ORIGINATION FORM

Proposed Revisions to a Standard Plans Index
(Please provide all information — Incomplete forms will be returned)

Index Number: 425-024
Sheet Number (s): ALL
Index Title: Curb Inlet Top Type 9

Reorganized Index, Added additional Sheets.
Sheet 1: General Notes
Sheet 2: Frame and Grate Details
Sheet 3: Top Slab Details

LAST REVISION 11/01/17	DESCRIPTION:	FDOT FY 2019-20 STANDARD PLANS	CURB INLET TOP TYPE 9	INDEX 425-024	SHEET 1 of 1
---------------------------	--------------	--------------------------------------	-----------------------	------------------	-----------------

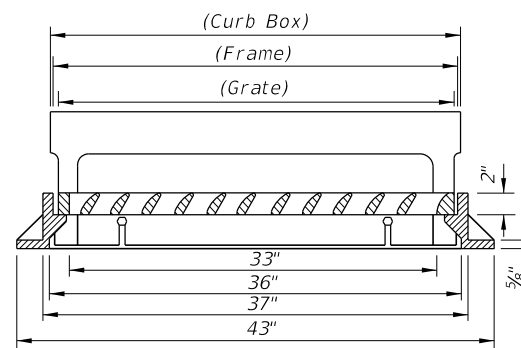
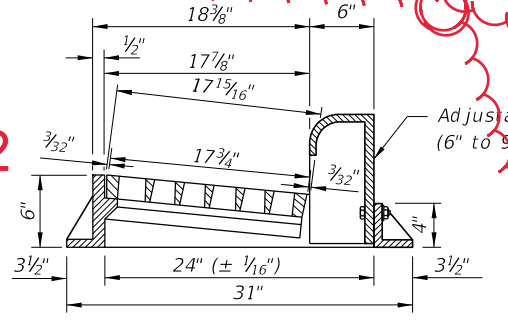
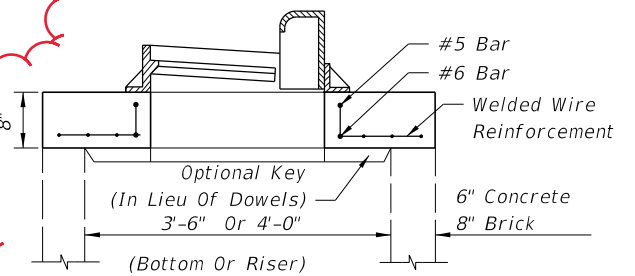
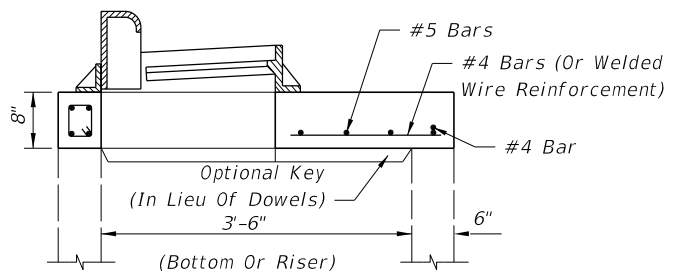
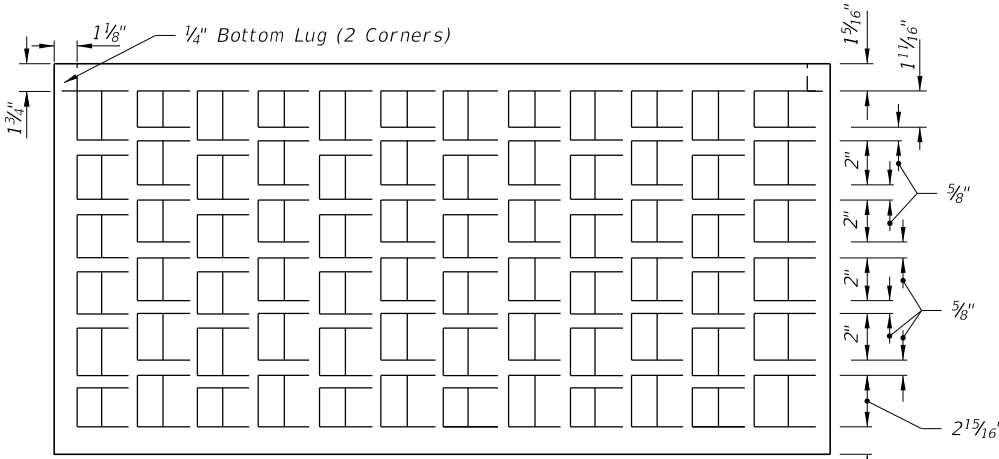
SPI

NOTES UPDATED

FRAME AND GRATE DETAILS

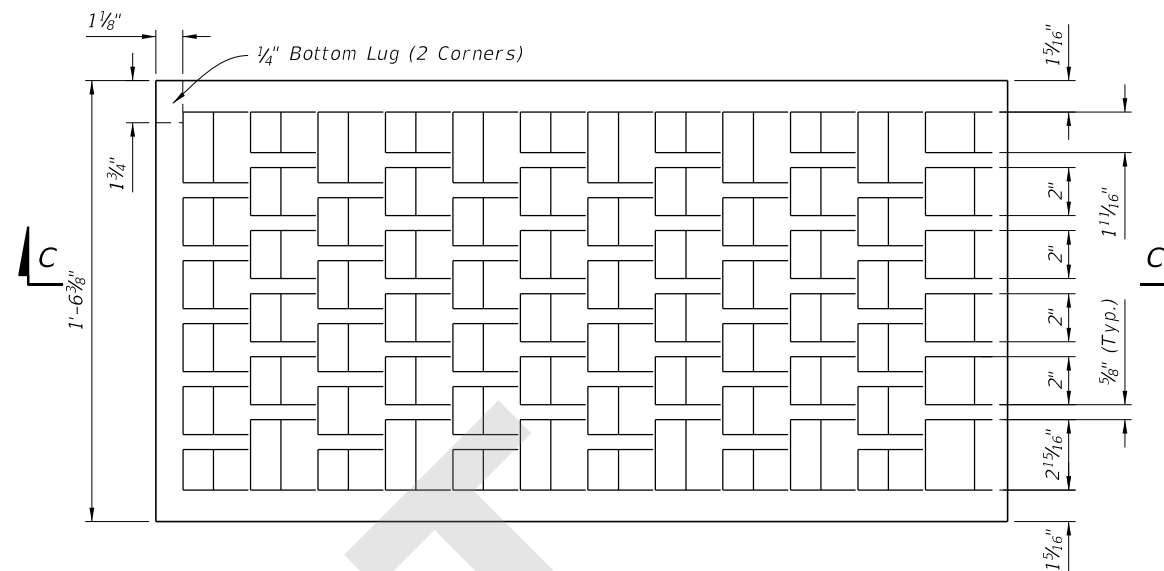
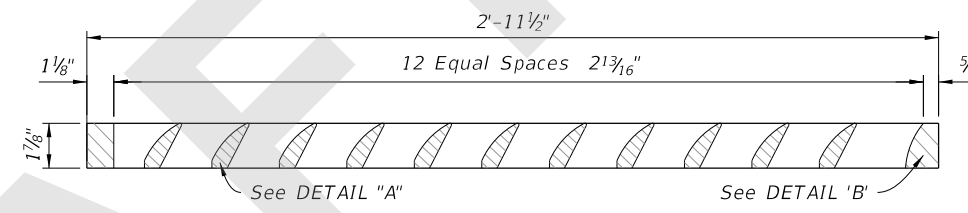
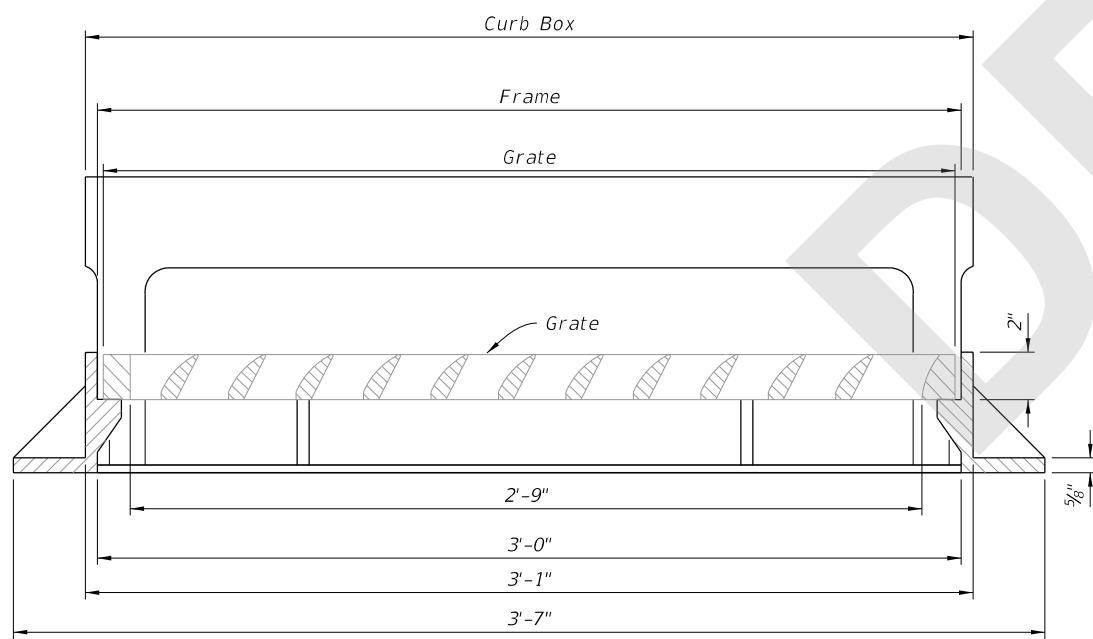
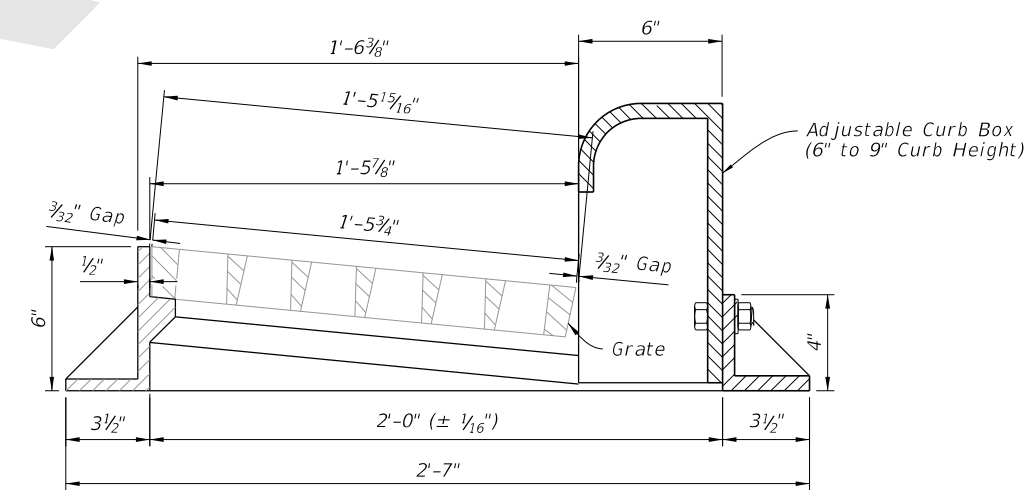
Reorganized Details and Sheets to declutter Index. Moved information from detail callouts to Notes in order to decrease clutter of the drawing. Moved design notes to SPI.
